INDIANA DEPARTMENT OF TRANSPORTATION

AGENDA

June 20, 2013 Standards Committee Meeting

SPECIFICATION, SPECIAL PROVISIONS AND DRAWINGS
REVISION TO STANDARD DRAWINGS

REVISION TO STANDARD DRAWINGS
605-CCSJ-01 CONCRETE AND ASPHALT CURBS AND SAWED JOINTS (WITH MARKUPS)

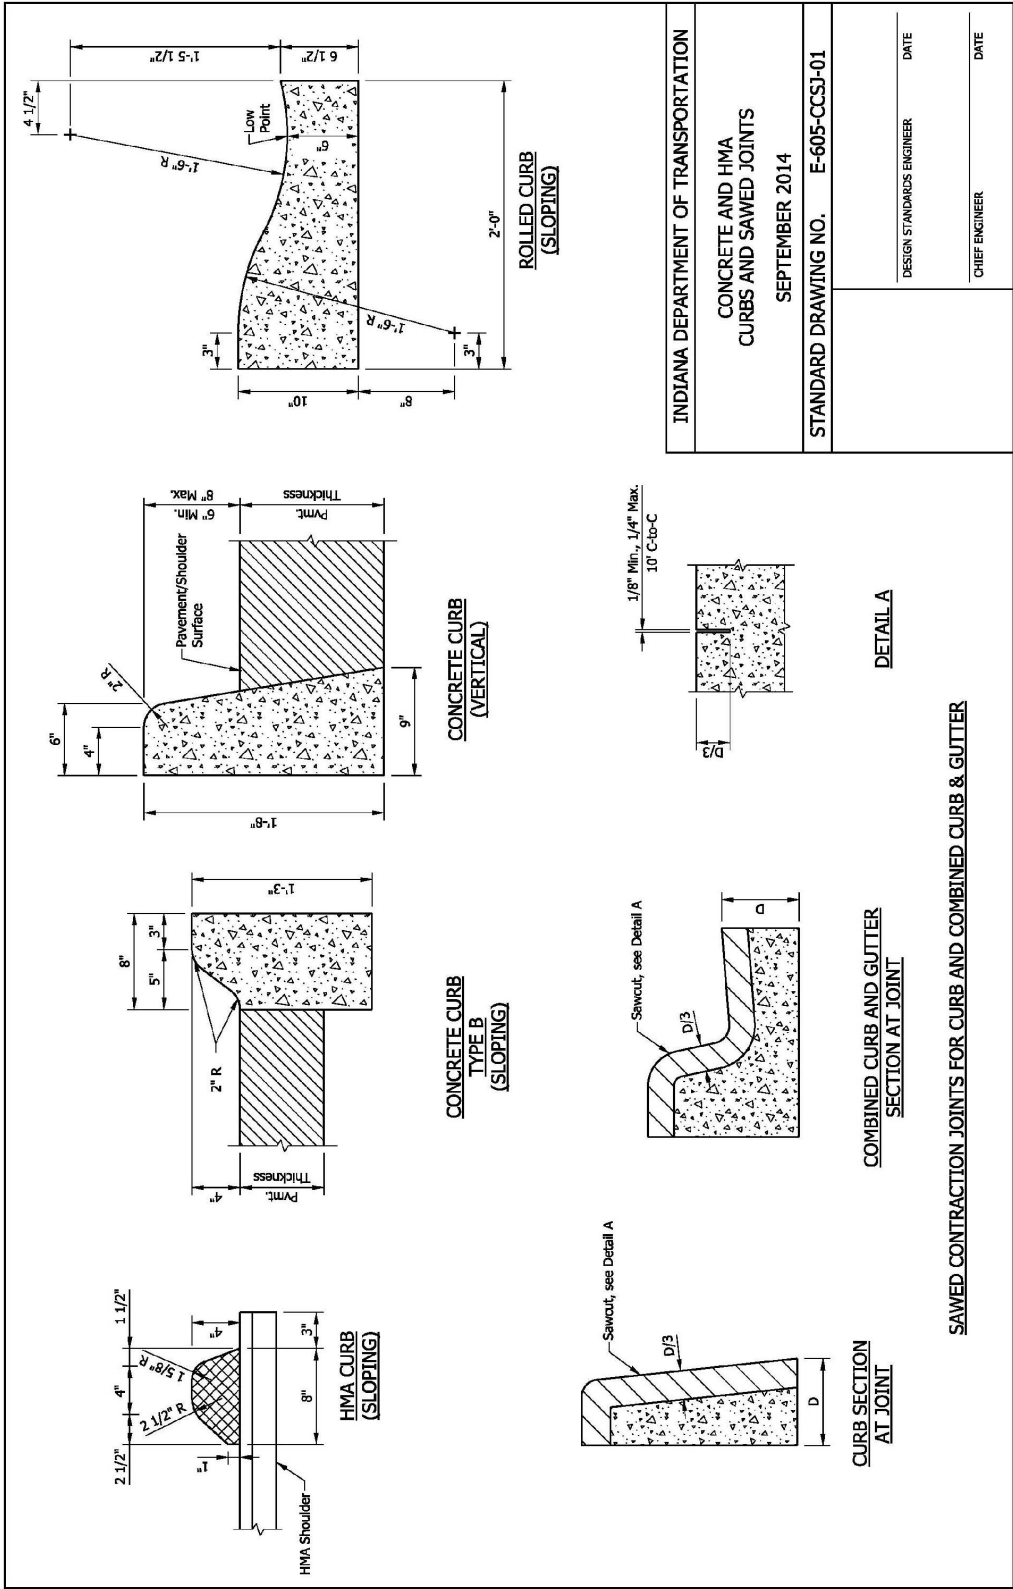
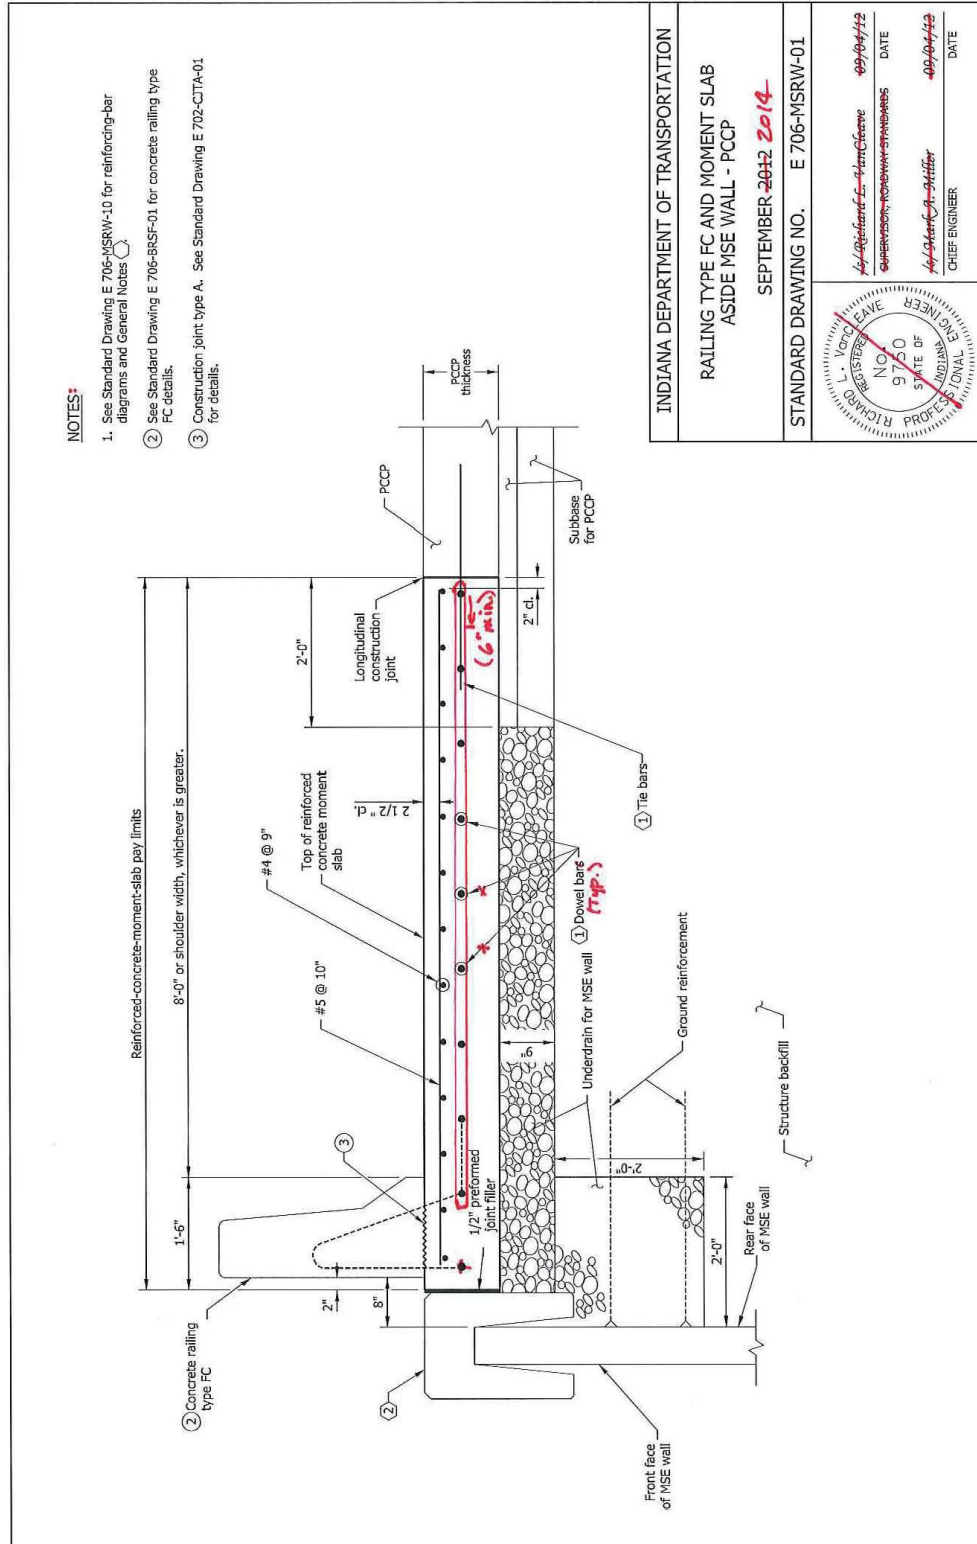
605-CCSJ-01: Corrected drawing of HMA Curb to more accurately reflect 4" height, updated terminology to agree with current practice and pay items ("Mountable" changed to "Sloping", "Barrier" changed to "Vertical", "Asphalt" changed to "HMA"), reorganized sections at joint, updated drawing format in general.

Update title block.

Update drawing format, text style, dimension style.

706-MSRW-01 RAILING TYPE FC AND MOMENT SLAB ASIDE MSE WALL - PCCP (WITH MARKUPS)

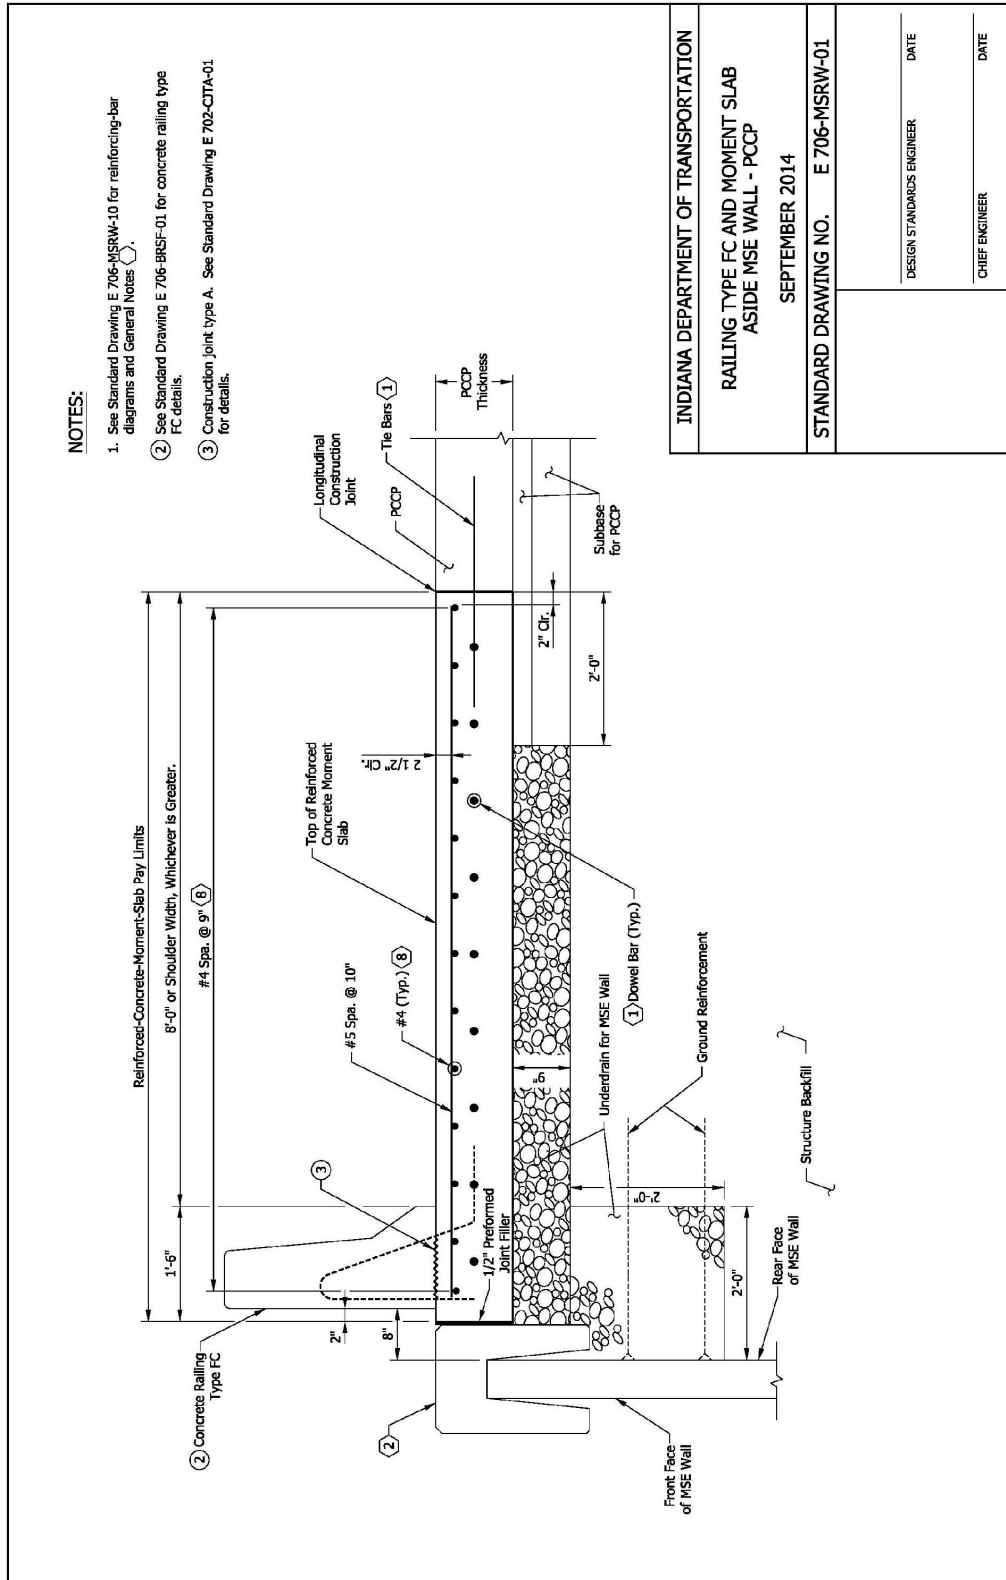
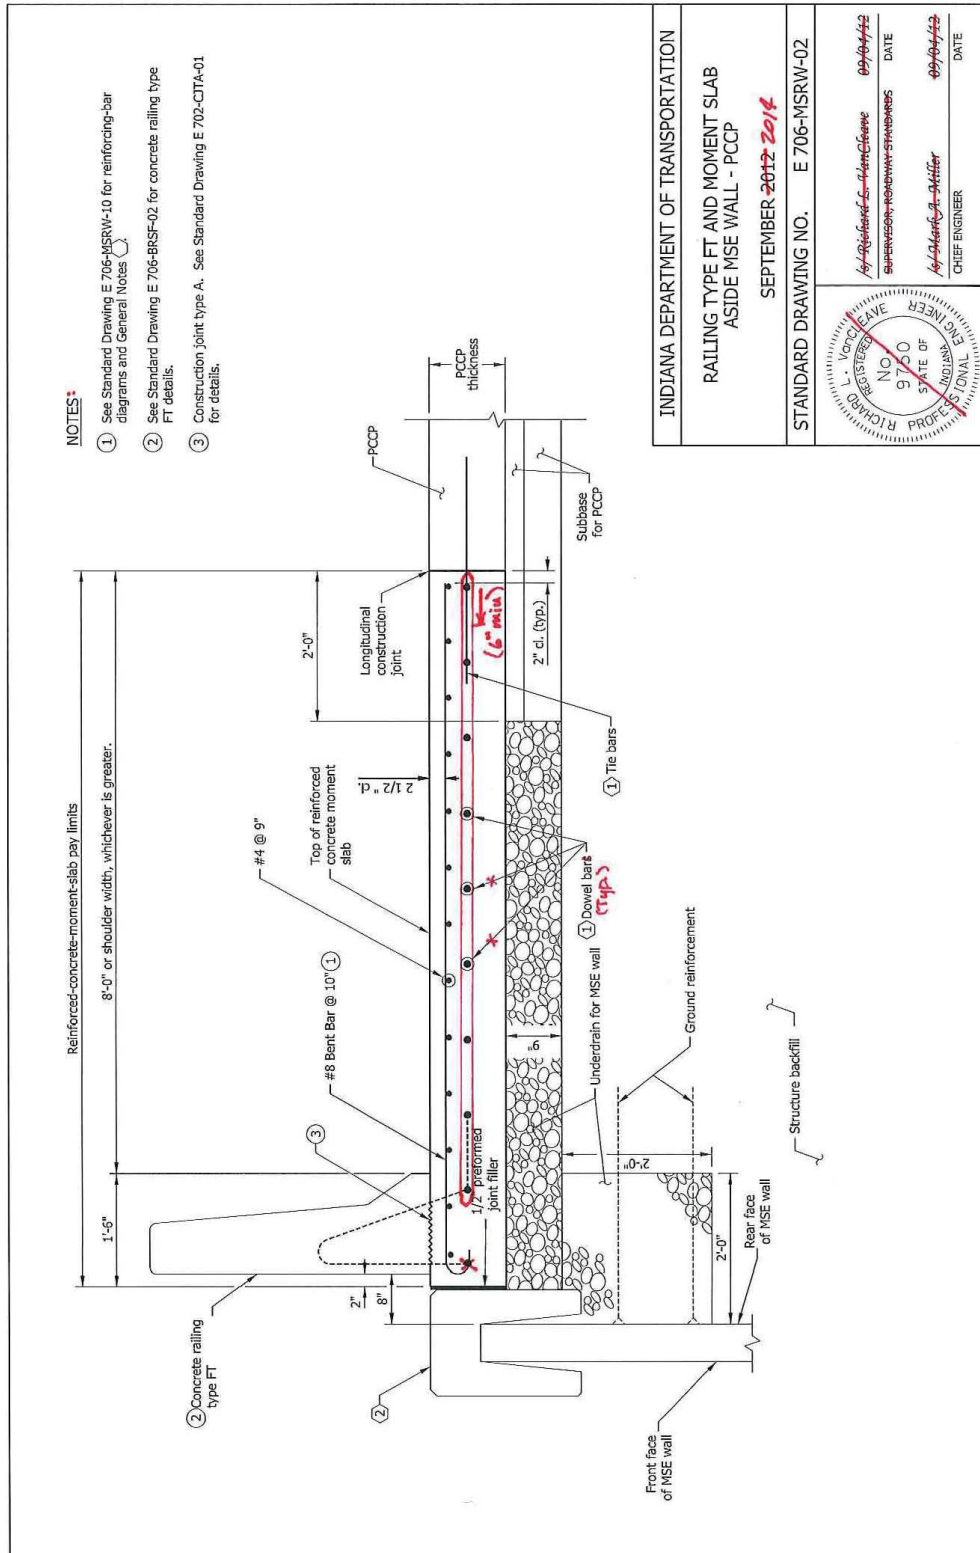
706-MSRW-01 thru -10: Relocated dowel bars in moment slab to reflect 6" minimum clearance from edge of pavement, updated drawing format in general.

706-MSRW-02 RAILING TYPE FT AND MOMENT SLAB ASIDE MSE WALL - PCCP (WITH MARKUPS)

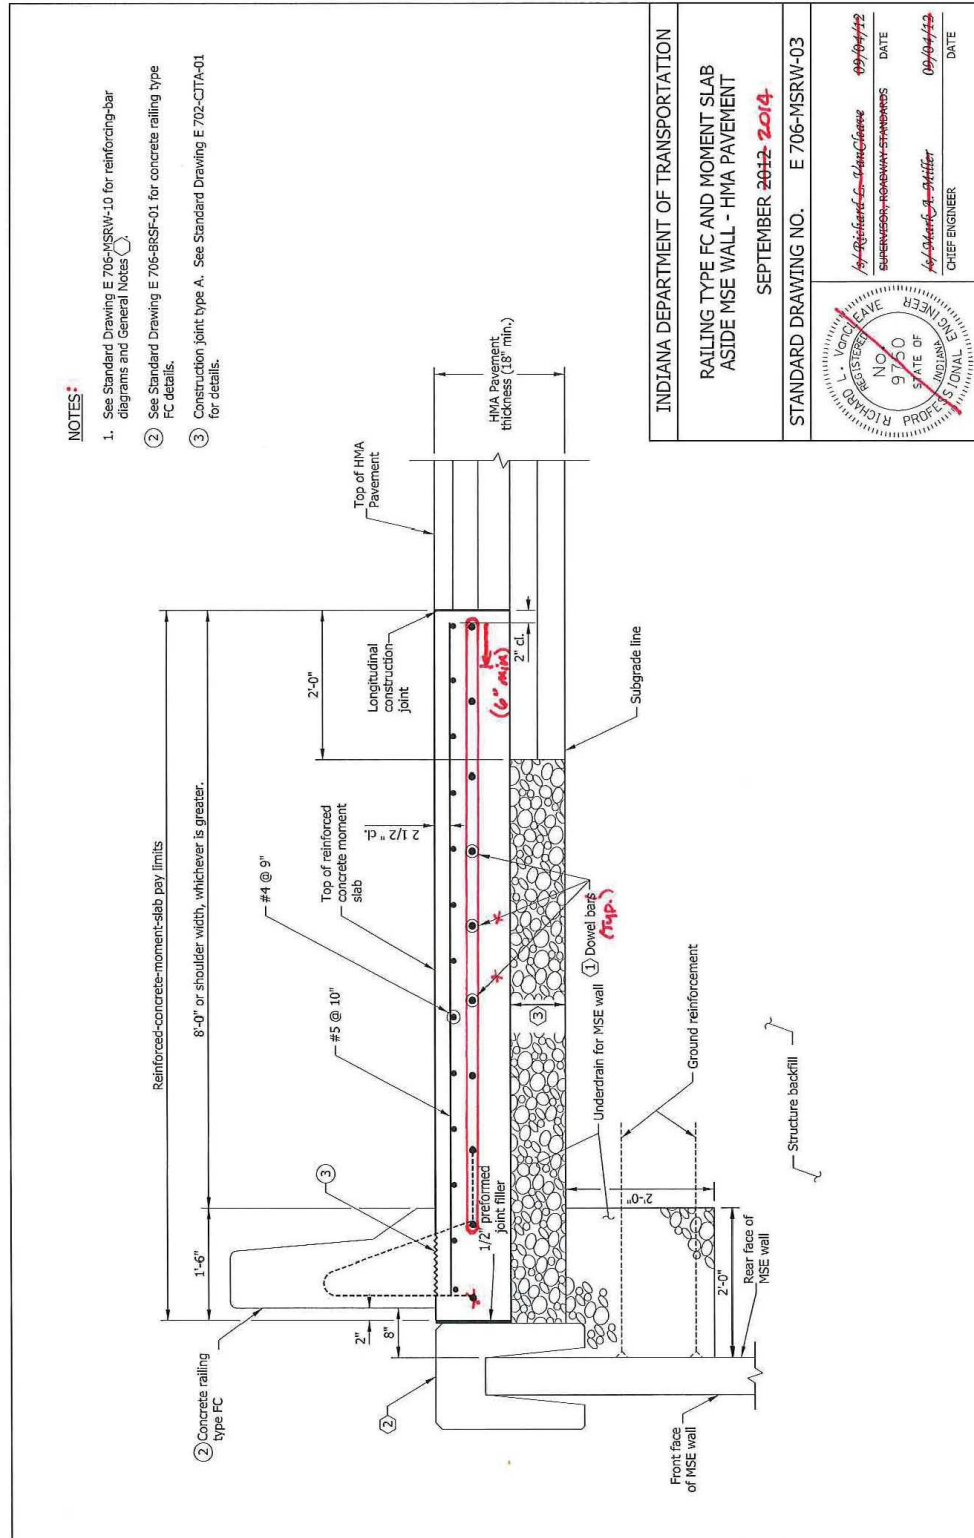
Update title block.

Update text style, dimension style.

706-MSRW-03 RAILING TYPE FC AND MOMENT SLAB ASIDE MSE WALL - HMA
PAVEMENT (WITH MARKUPS)

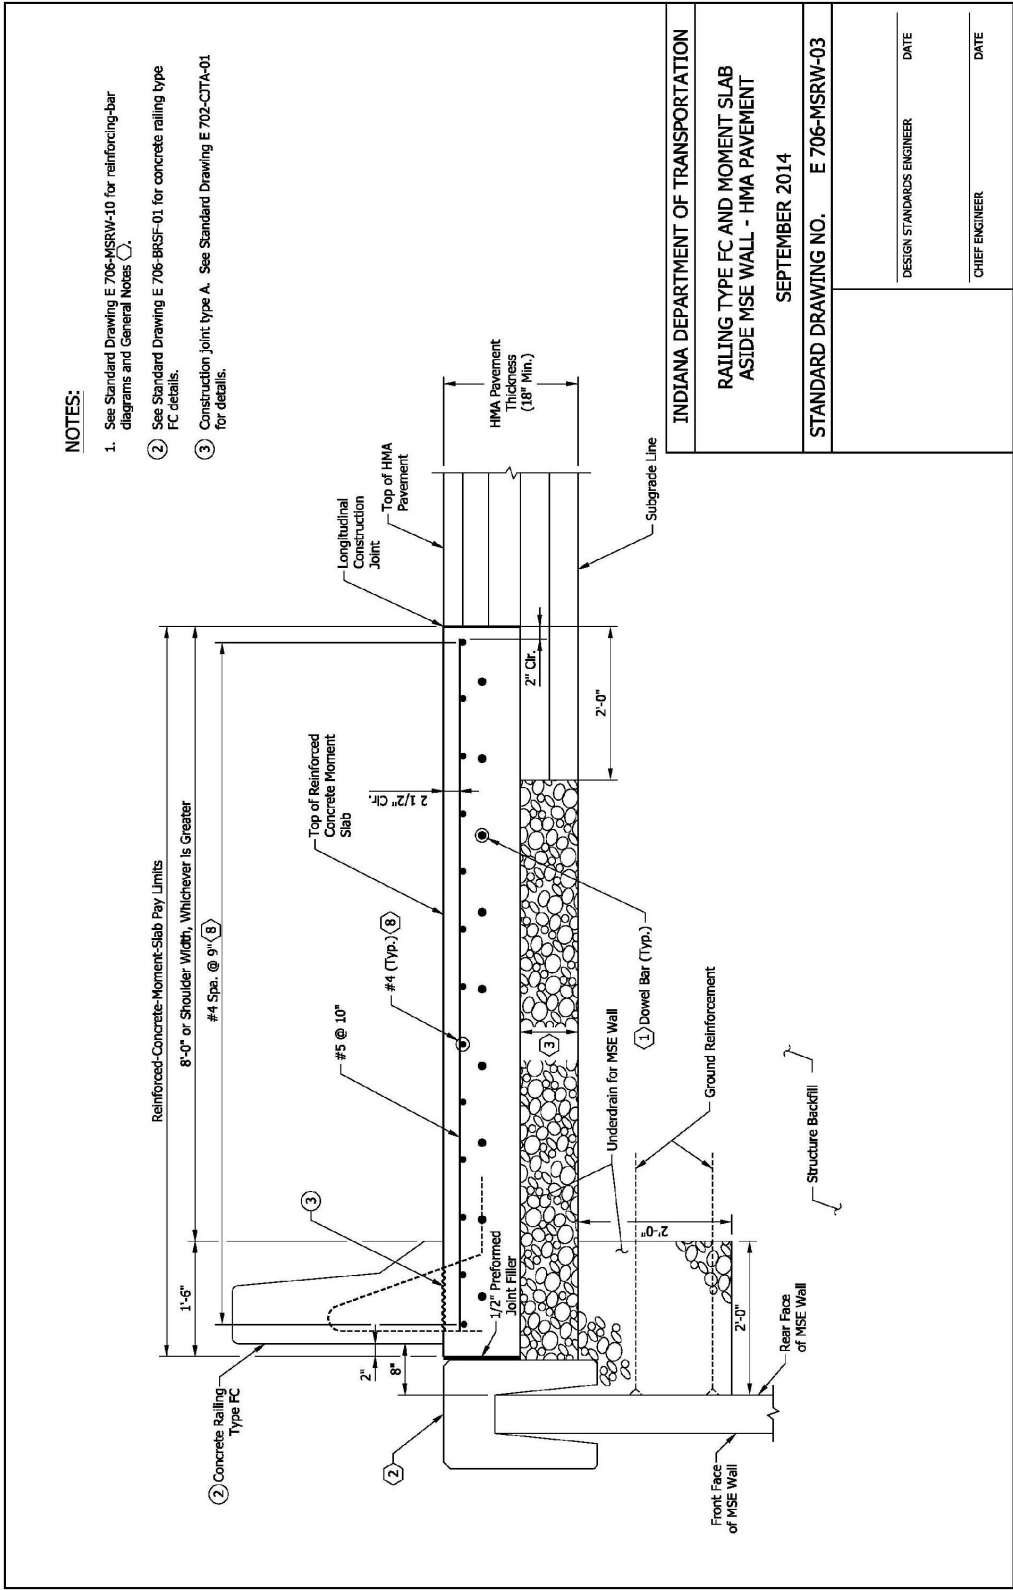
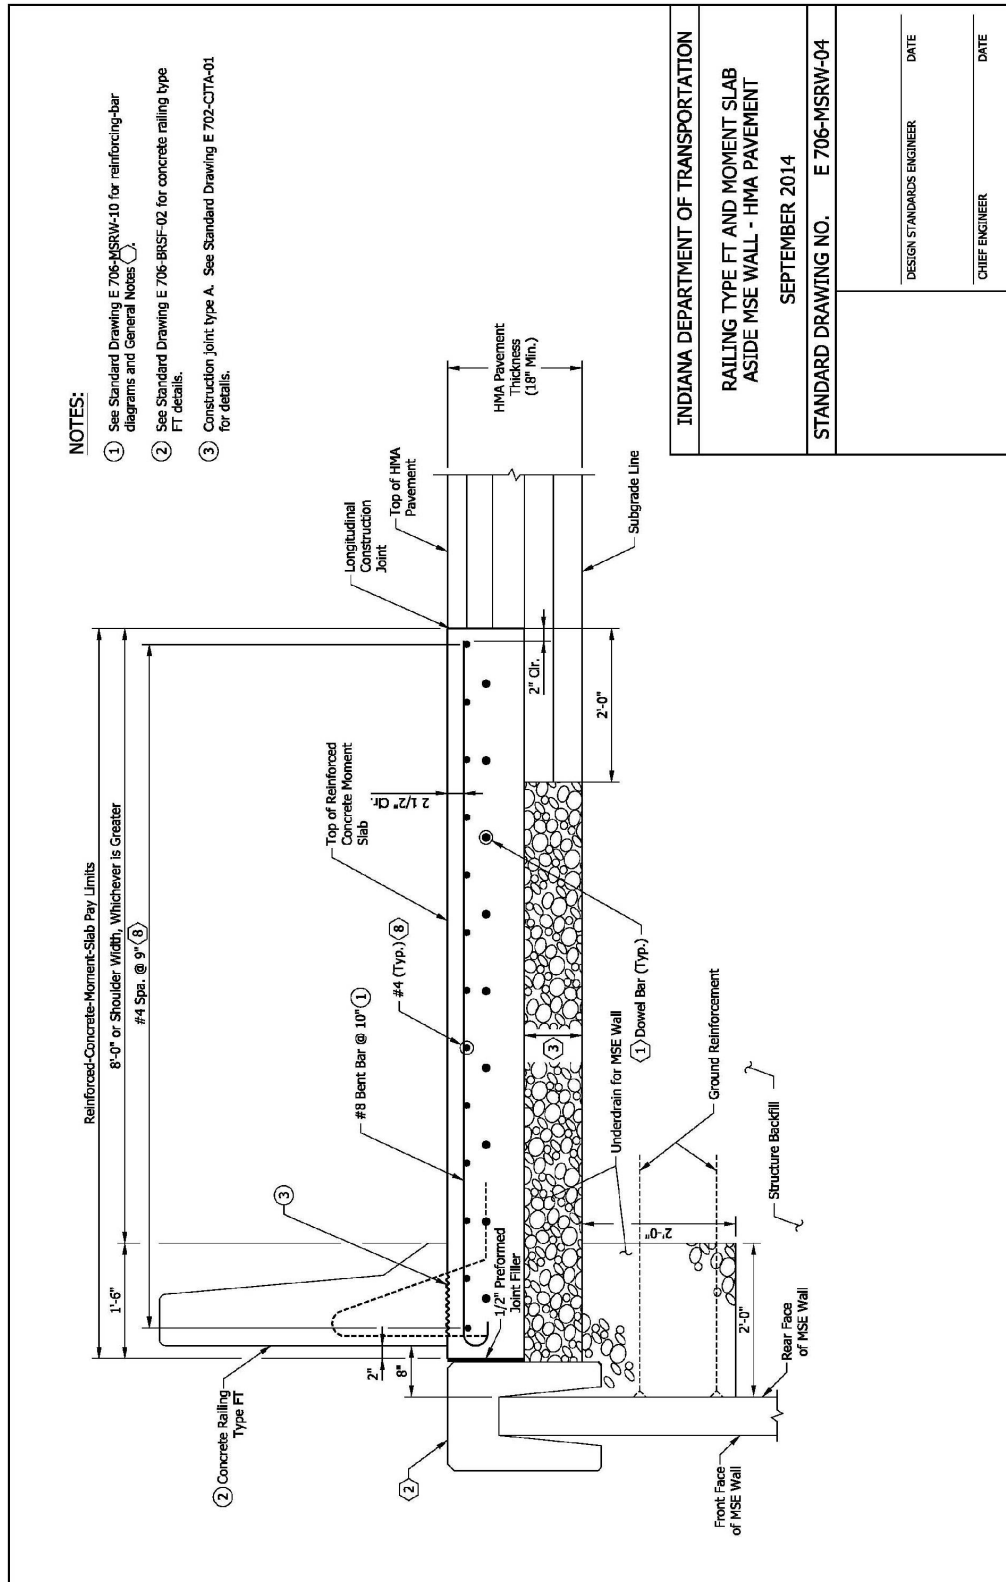
Update title block.

Update text style, dimension style.
